SUBJECT: Forwards evaluation & revised pages to Uprating Licensing Rept, (WCAP-14276, Rev 1) w/respect to reactor coolant flow-low reactor trip setpoint used in analyses.

Re: Turkey Point Units 3 and 4
Docket Nos. 50-250 and 50-251
Updated Analysis
Proposed License Amendments
Thermal Power Uprate

An inconsistency was identified between the Reactor Coolant Flow-Low Reactor Trip Setpoint in the proposed Thermal Power Uprate Licensing Amendment (L-95-245 dated December 18, 1995) and the corresponding setpoint used in the safety analyses described in the Uprating Licensing Report (WCAP-14276, Revision 1). Both setpoints are based on 84.5% of the reactor coolant system (RCS) flow. However, the proposed uprate value is based on a Thermal Design Flow (TDF) of 85,000 gpm/loop while the analysis value was based on the Minimum Measured Flow (MMF) of 88,000 gpm/loop.

Figure 3.2.8-5 Flow Coastdown versus Time
Partial Loss of Forced Reactor Coolant Flow
(All loops initially operating, two loops coasting down)

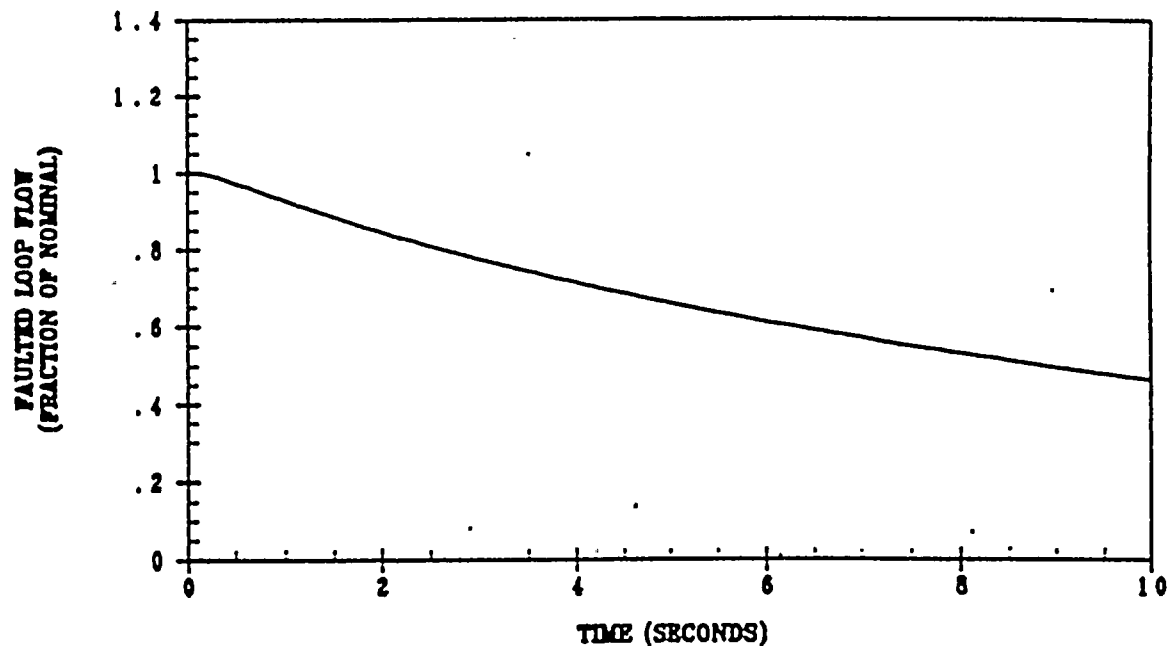
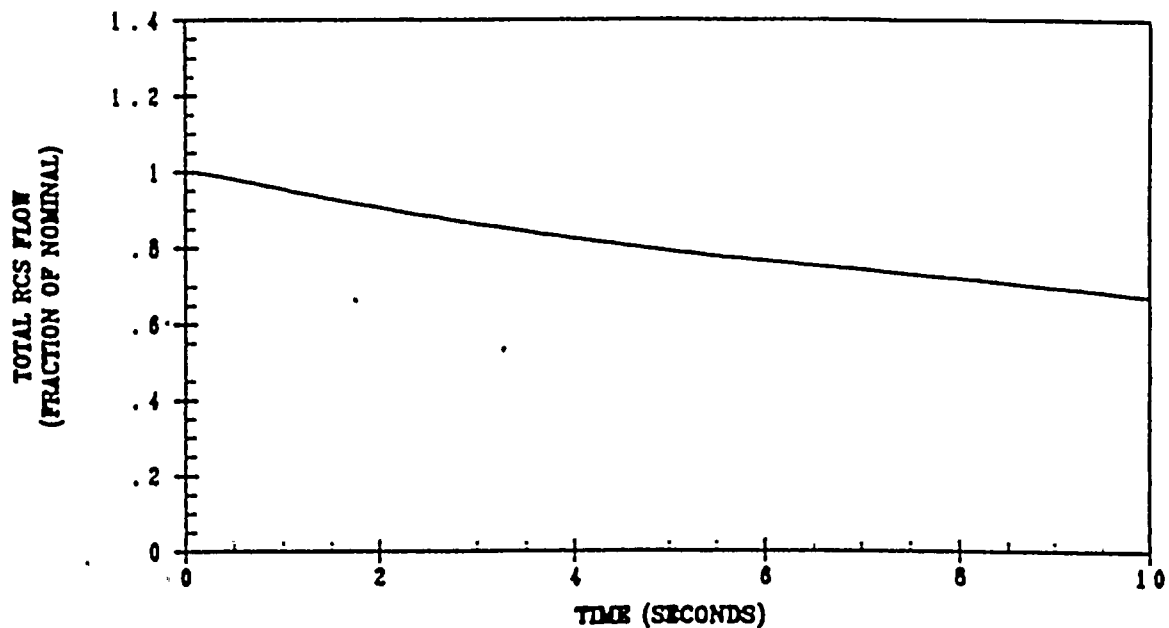
For the Partial Loss of Forced Reactor Coolant Flow, the impact of the change in setpoint value is a delay of 0.3 seconds in the time of trip actuation. The original analysis resulted in a time to reactor trip of 2.0 seconds. The revised analysis establishes a time to reactor trip of 2.3 seconds. This delay has no significant impact on the results of the transient. Updated pages 3-69, 3-76, 3-77, 3-78 and 3-79 of the Uprating Licensing Report (WCAP-14276, Revision 1) which reflect the revised analysis are provided in Attachment 2.
